### ADDENDUM No. 2

REQUEST FOR QUOTATIONS No.:	1220-040-2023-043
TITLE:	RCMP Main Headquarters Cooling Tower Replacement
ADDENDUM ISSUE DATE:	August 10 <sup>th</sup> , 2023
REVISED CLOSING DATE AND TIME:	The City would prefer to receive Quotations on or before August 16 <sup>th</sup> , 2023.

**SUPPLEMENTAL PHOTOGRAPHS:**

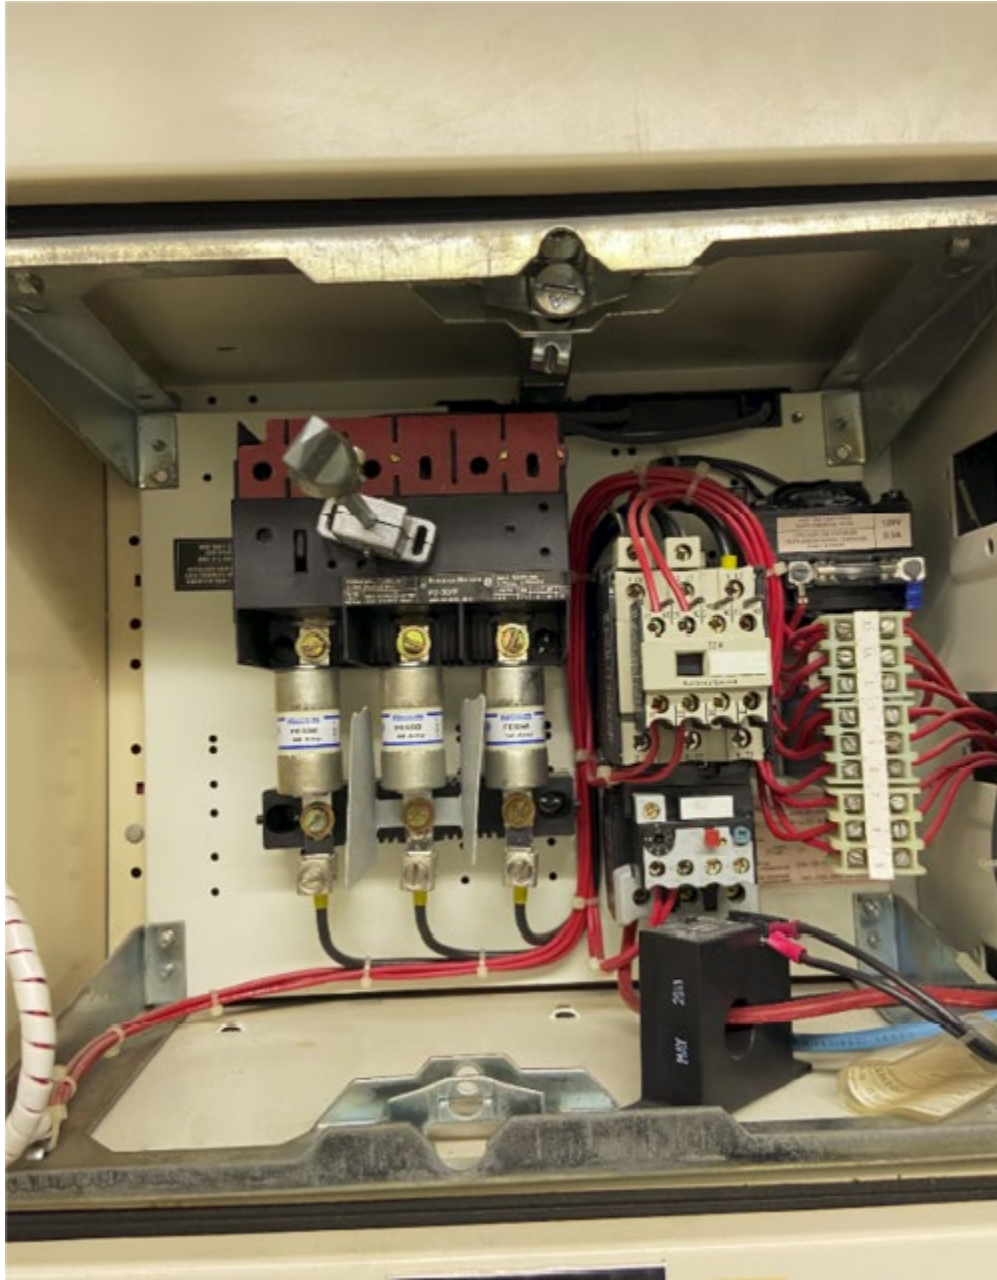
- Q4.** Please provide pictures of the panel nameplates that are feeding these new loads to price the breakers.
- A4. The project design team does not include an electrical consultant and therefore, any electrical scope of work will be completed as a design build approach. Please refer to the Supplemental Photos at the end of this addendum.**
